LT459 – Fanellan 400kV Substation

Flood Risk Assessment

FNLN-LT459-FAI-DRAI-XX-RPT-W-0001

REPORT TITLE: Flood Risk Assessment

Figure 5-1: Comparison of Donor Catchments

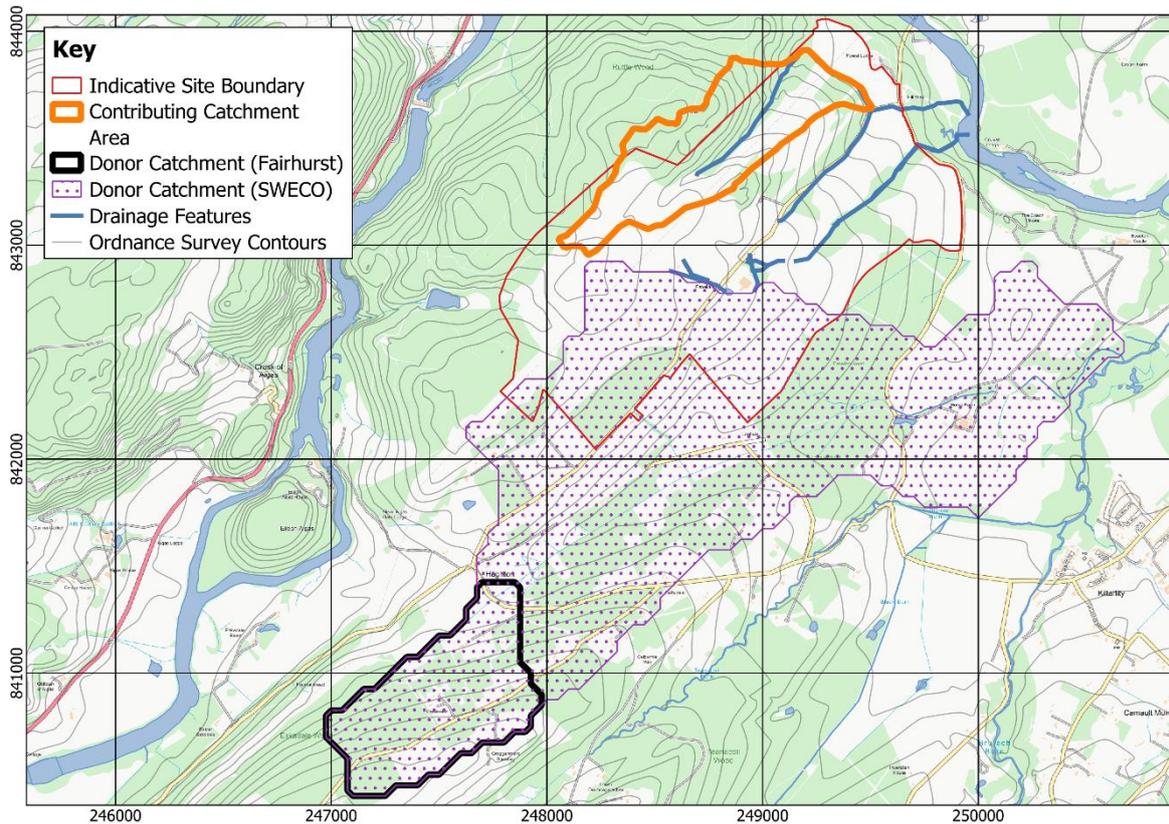
5.2.1 SEPA Letter, Paragraph 1.4, a SEPA Comment

The previous FRA performed by SWECO for this application calculated the 1:200 year + climate change flow to be 0.93m³/s, which we checked as being suitable for this assessment. This flow value should be used in further assessment unless otherwise suitably justified.

The SWECO hydrological assessment using the ReFH2 method referred to in the SEPA correspondence resulted in a 1 in 200 year + climate change peak of 0.93 m³/s. The SWECO assessment used a different 'donor catchment' to the Fairhurst assessment, however this is considered to be less suitable based on catchment characteristics, as exemplified by the proportional difference in catchment area compared to the study catchment. The differences are set out in **Table 5-1** and illustrated in **Figure 5-1**: below.

Fairhurst has attempted to replicate the analysis undertaken by SWECO using the equivalent donor catchment and adjusting parameters in line with the values set out in Appendix B of the SWECO FRA. However the results indicate that the resultant 1 in 200 year + climate change peak flow was $0.73 \text{ m}^3/\text{s}$ using FEH22 rainfall data, or $0.83 \text{ m}^3/\text{s}$ using FEH 13 rainfall data, which differ from the $0.93 \text{ m}^3/\text{s}$ stated in the SWECO FRA and in SEPA's recent correspondence.

The Fairhurst assessment of peak flows is considered to be robust and justifiable for use within this Flood Risk Assessment.

Figure 5-4: Comparison of Existing Flood Levels to the Hill View Property Elevation

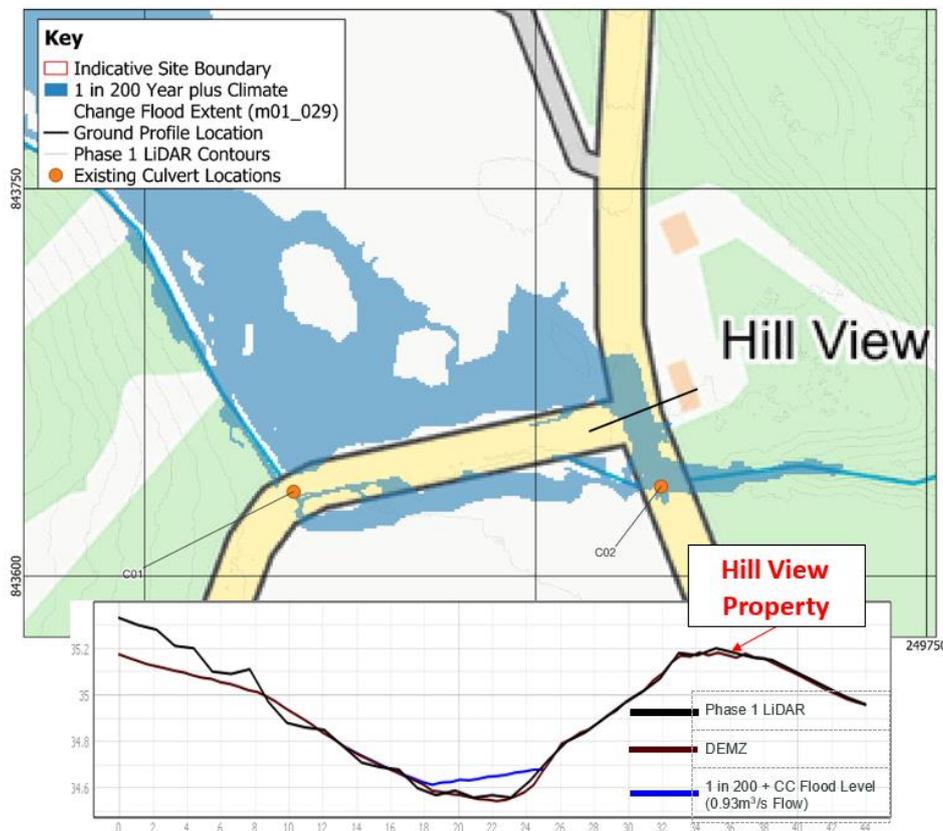
SEPA Comment

Detailed topographic data is available which covers the majority of the hydraulic model domain, as shown in Drawing No. FNLN-LT459-FAI-ZZ-ZZ-SUR-C-0001 included at the end of this appendix. Beyond the extent of the detailed topographic survey Scottish Government Phase 1 LiDAR data is available and has been used within the hydraulic model. Checks have been undertaken which demonstrate that the LiDAR ground levels are consistent with the detailed topographic survey levels and are therefore reliable for use within the model. Furthermore there are no 'steps' between the two datasets at the data boundaries which could cause erroneous hydraulic outputs.

Figure 5-4: below provides a comparison of topographic survey and LiDAR levels in the vicinity of the Hill View property which demonstrates the close correlation. This also demonstrates that there is a slight rise from the road up to the boundary of the Hill View property. As the predicted overland flow in this area is shallow the level difference is sufficient to constrain flood extents in a 1 in 200 year + climate change event to the roadway without inundating the Hill View property. Additional information on flood risk in relation to the Hill View property is provided in subsequent sections.

Figure 5-5: Comparison of the 1m Cell Size Flood Extents to the 0.5m Grid Size Flood Extents for the Baseline Scenario (1 in 200 Year plus 42% Climate Change Scenario)

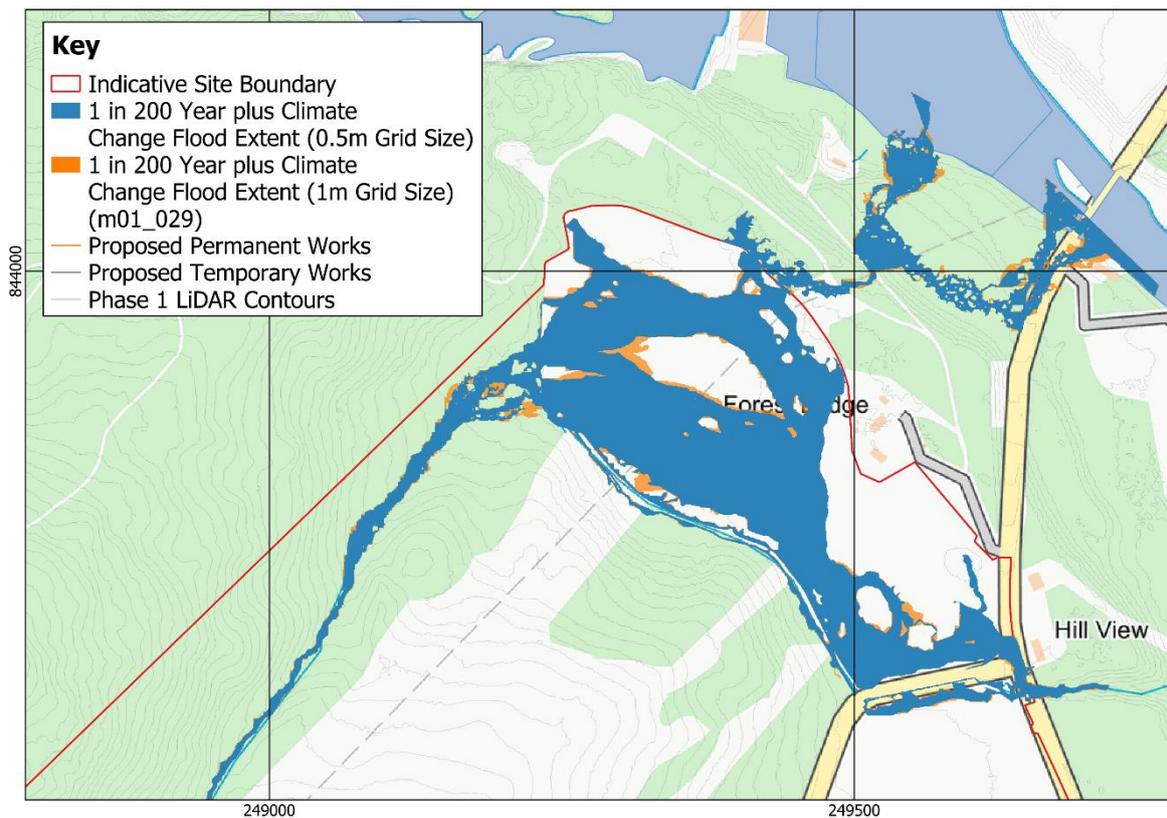
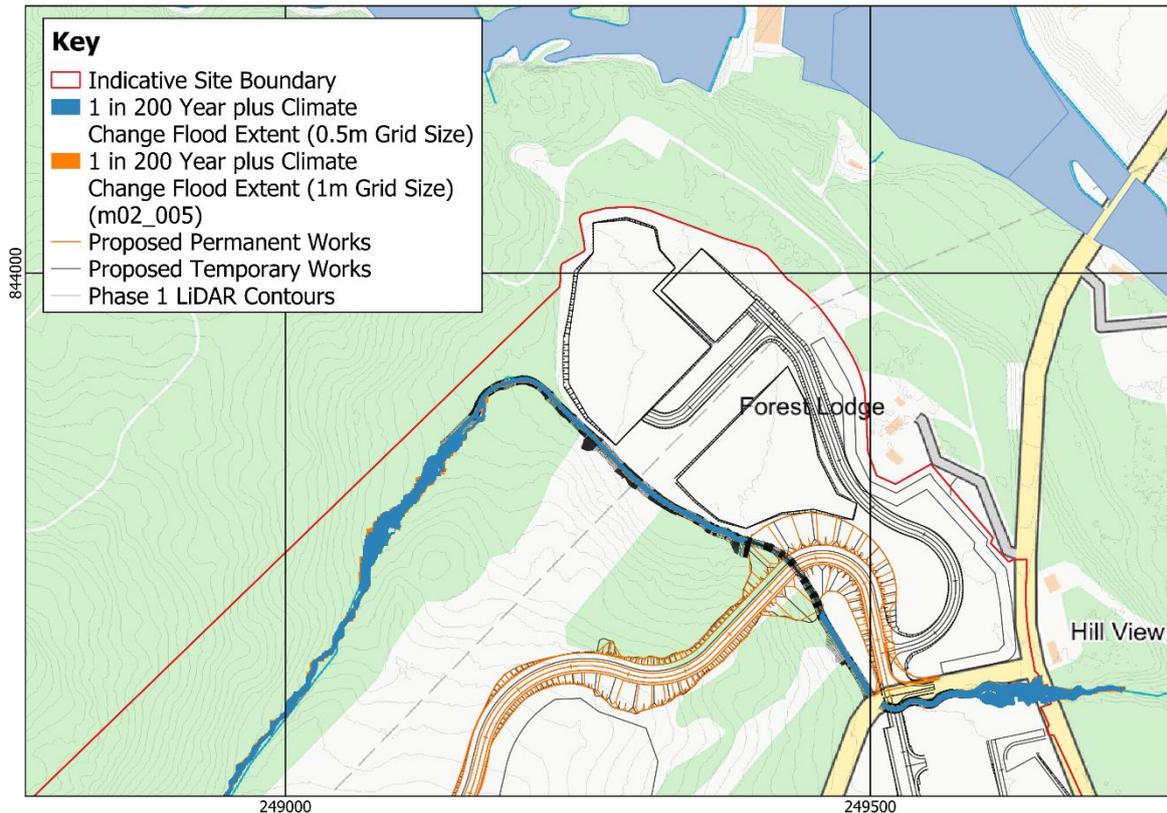
SEPA Comment

Has cell size convergence testing been undertaken for the 2D model?

Cell size convergence testing has been undertaken for the existing and proposed mitigation scenario by comparing a 1m cell size to a 0.5m cell size. For both scenarios there are marginal differences in flood levels ($\pm 0.002\text{m}$ in the baseline scenario and $\pm 0.050\text{m}$ in the proposed mitigation scenario). This results in negligible differences in flood extents, as shown in the figures below. The choice of cell size used in the model is therefore considered to be robust.

Figure 5-7: Comparison of the 100% blockage of culvert C02 Flood Extents to the unblocked culvert Flood Extents for the Baseline Scenario (1 in 200 Year plus 42% Climate Change Scenario)

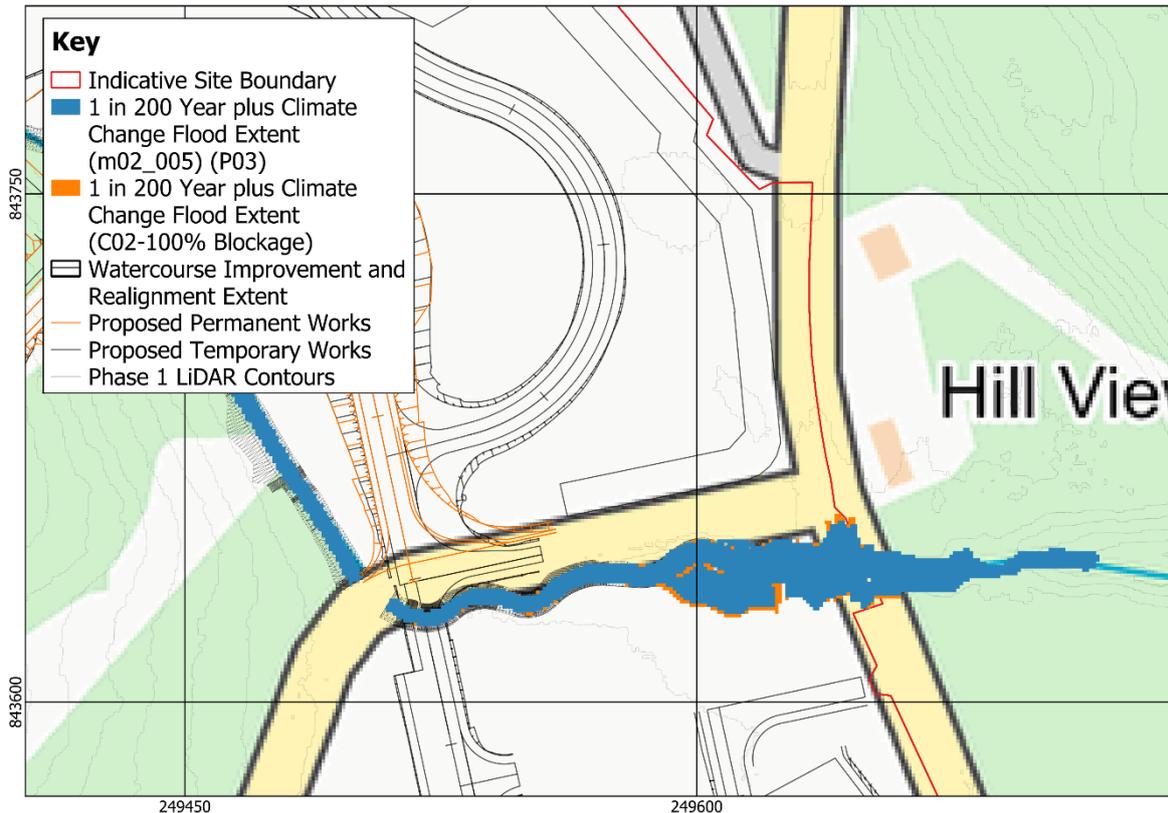
SEPA Comment

access track compared to a 0% blockage scenario. The resulting flood extents are indicated in **Figure 5-7:** and **Figure 5-8:**.

The results demonstrate that the Hill View property is not at risk of flooding in a 1 in 200 year + climate change event with 100% blockage of culvert C02 and that the proposed mitigation measures would reduce flood extents in the vicinity of the property compared to existing.

Figure 5-9: Location of Flood Level Blockage Results Sampling Points for the Existing and Proposed Mitigation Scenarios

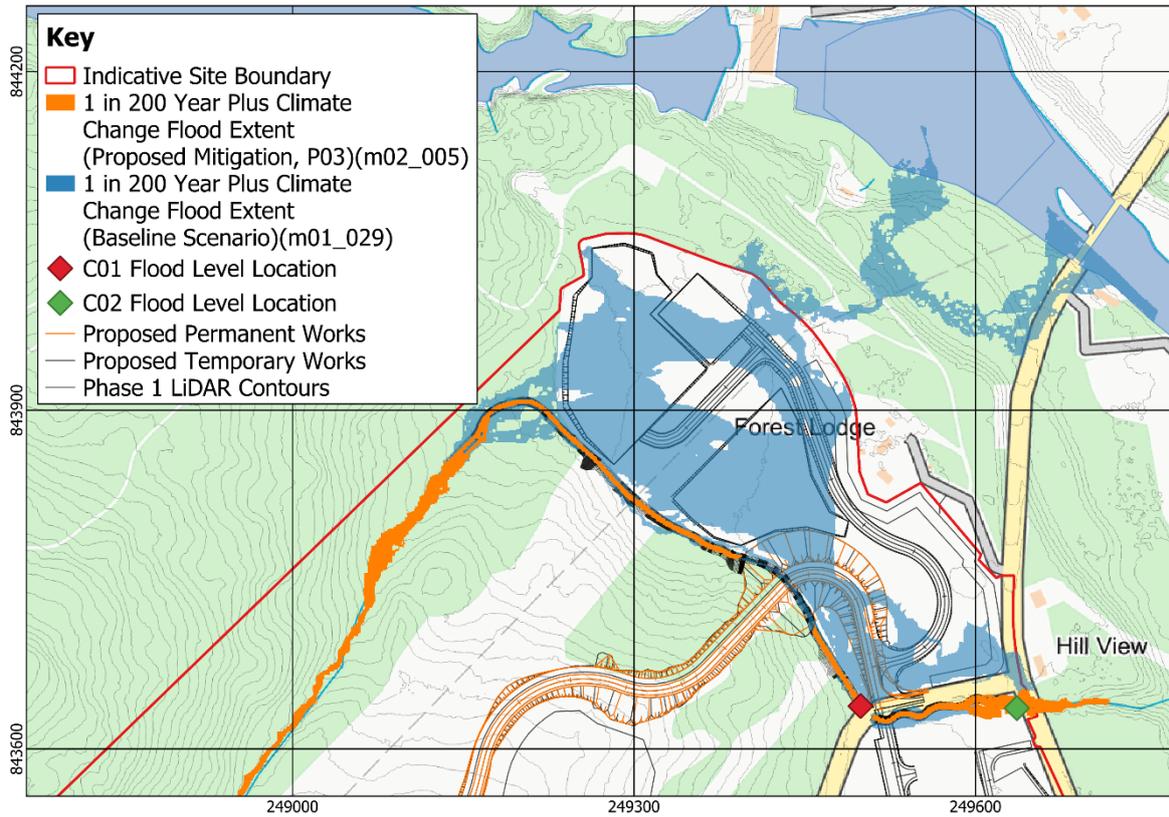
SEPA Comment

Flood level information should also be presented for 0% blockage, 50% blockage and the 100% blockage pre and post development scenarios. Ideally these could also be compared to the minimum elevation of the Hill View property.

The flood levels for the 0%, 50% and 100% have been extracted from the model results at the locations shown in **Figure 5-9**;, and these are provided in **Table 5-1**.
